## FCC Class II Permissive Change for FCC ID: ZNFHBSSL6S

This is to request a Class II permissive change for FCC ID: ZNFHBSSL6S, originally granted on May 02, 2019. The device is identical to the previously certified LG STEREO Headset except for the modification following:

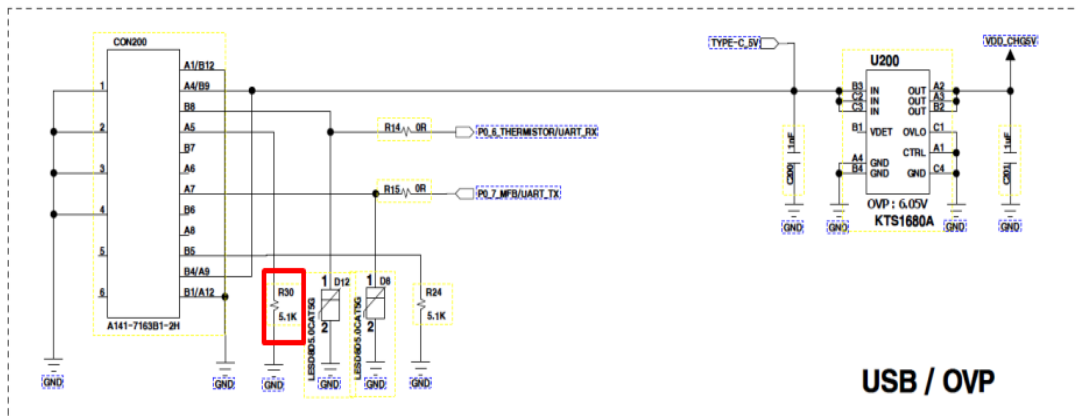
- Add Pull down resistor(R30, 5.1K) to improve reverse charging on TYPE-C adapters.
